ZONING MAP CHANGE STAFF REPORT

Site Location: 10300 Forest Hill Everman Road Acreage: 20.58

Request: From: "CR" Low Density Multifamily

To: Planned Development for all uses in "C" Medium Density Residential adding

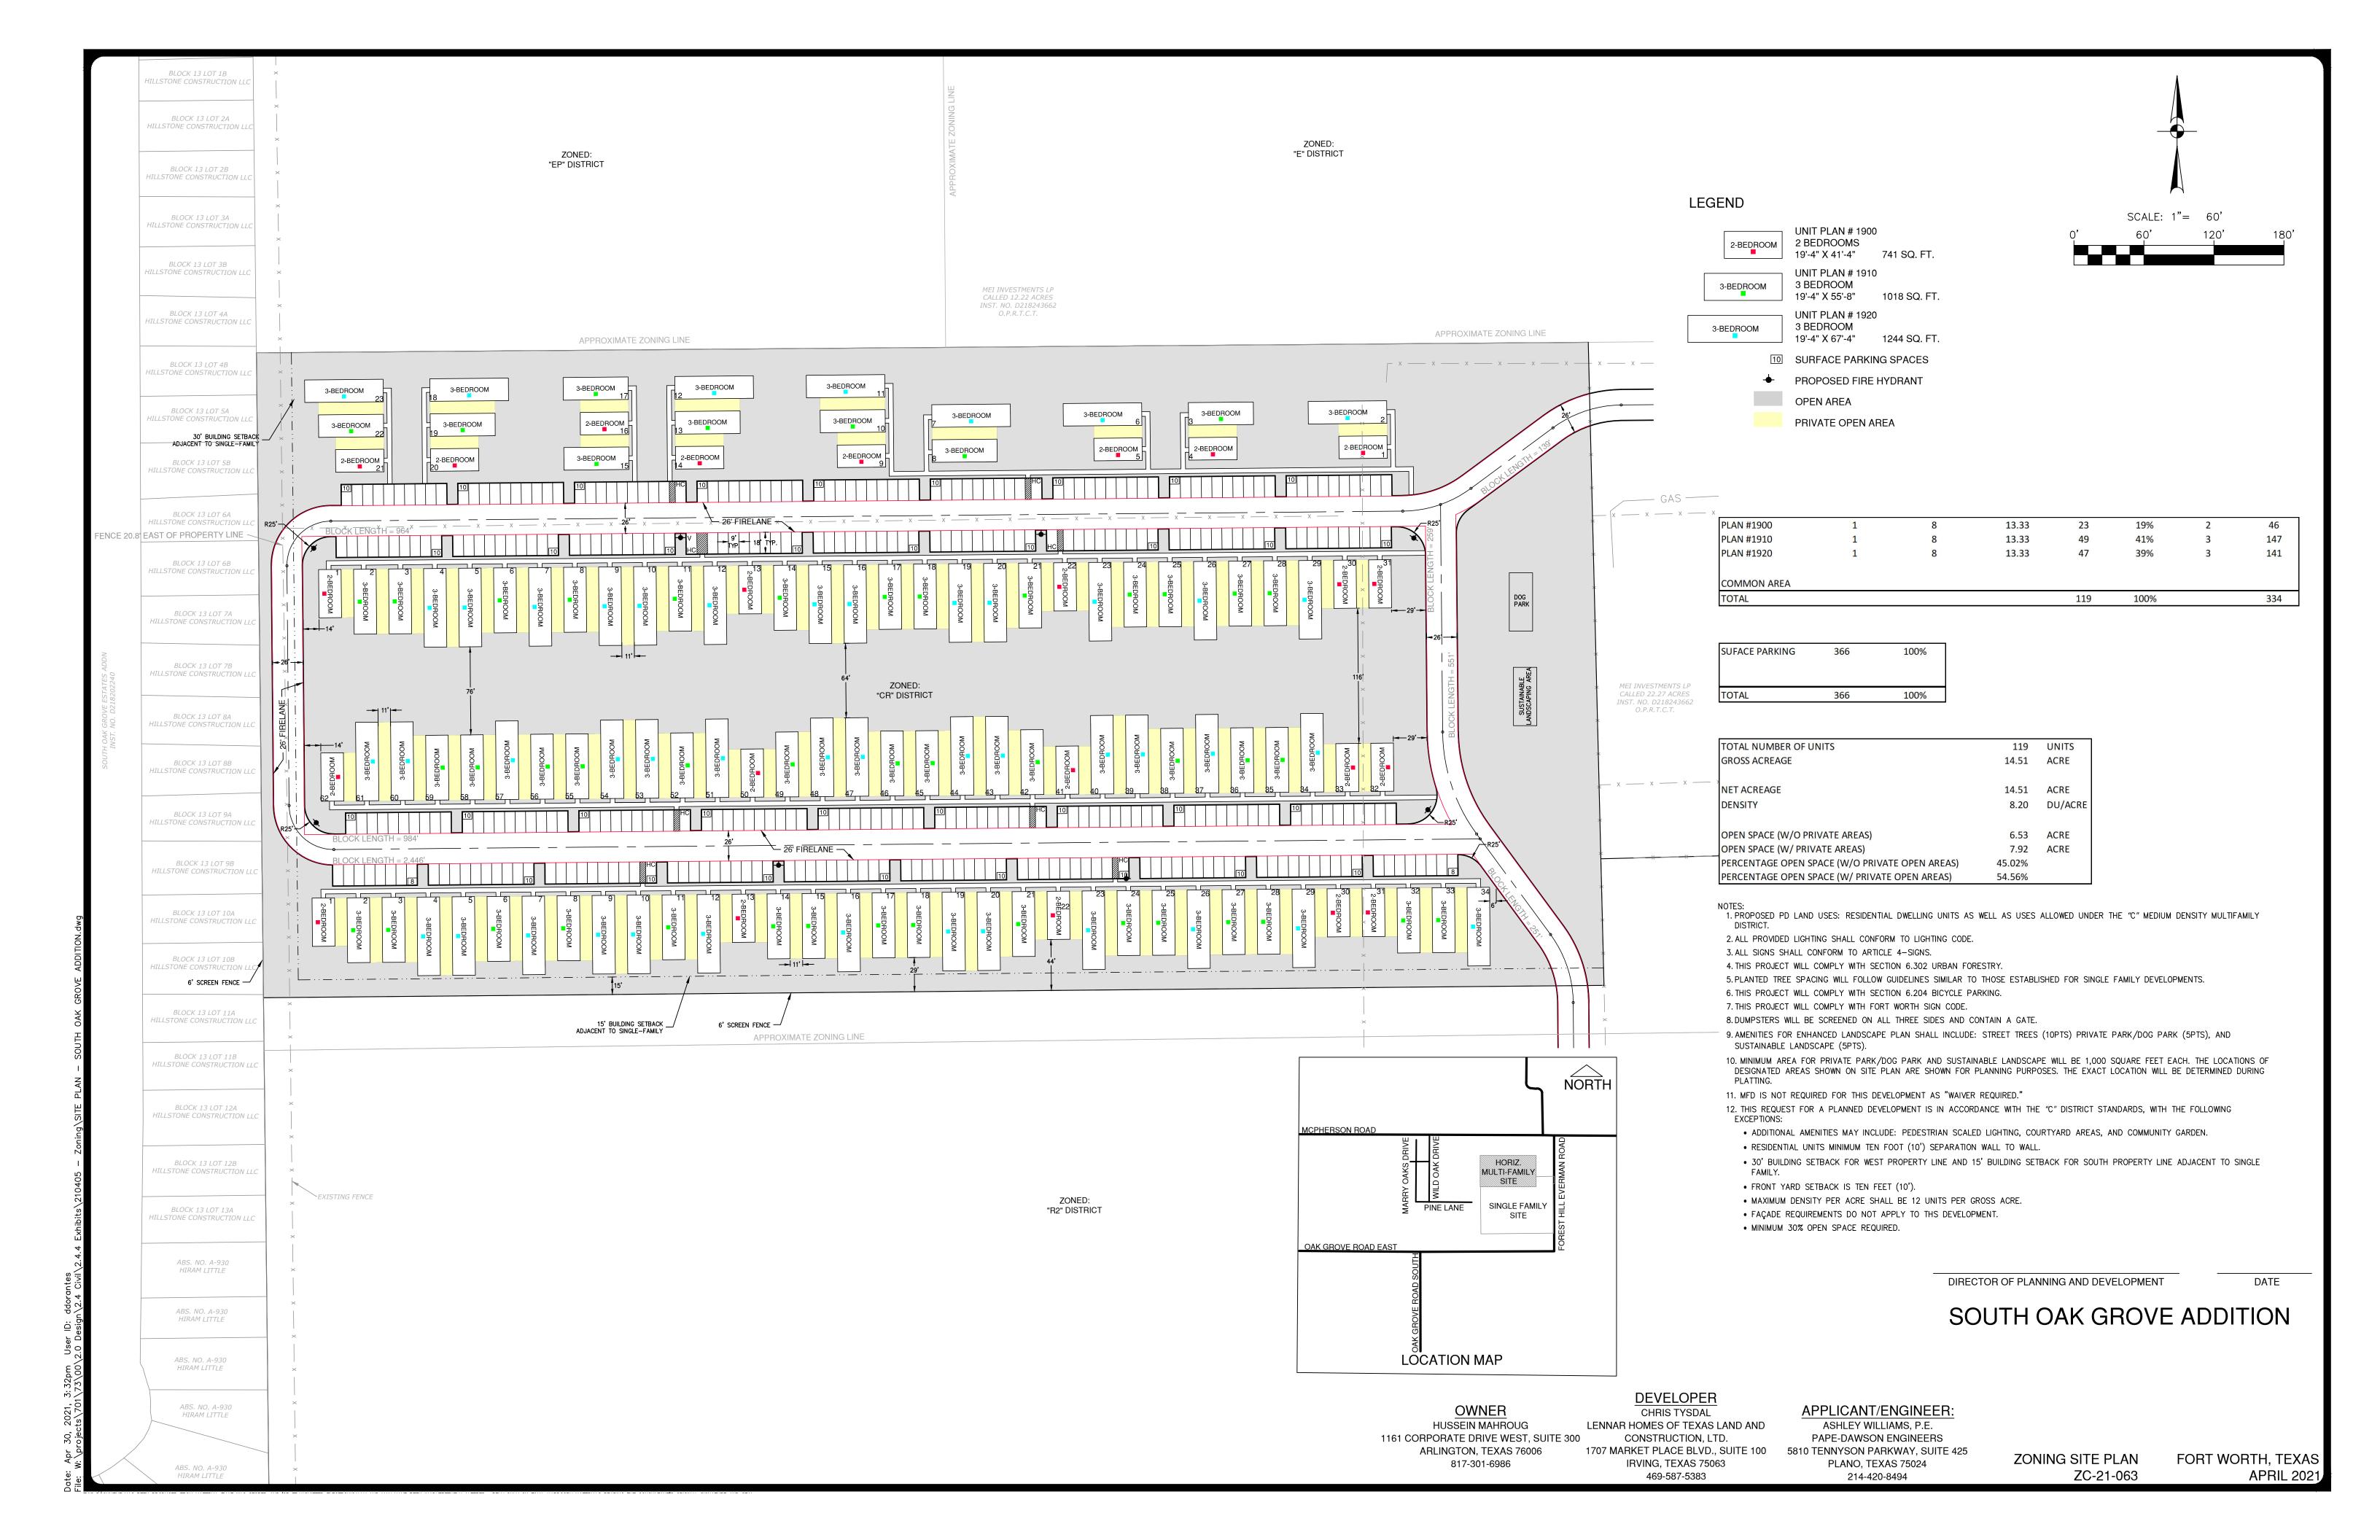
Site Plan Comments:

The site plan as submitted is in general compliance with the Zoning Ordinance regulations.

- 1. Open space is only counted if no less than 25' in either dimension. Patios adjacent to dwelling units, unless enclosed, may be included as part of the open space.
 - Analysis: Detached multifamily operates differently than traditional "C" medium density residential developments. Due to the separation of individual, detached units, the public open space is often smaller than the 25'x25' minimum dimension. For the purpose of this site plan, the enclosed side yards for each dwelling unit will be acceptable as open space. The yards, while private, are spaces the residents can use, as they do not have a building built there. Meets overall intent of the ordinance.
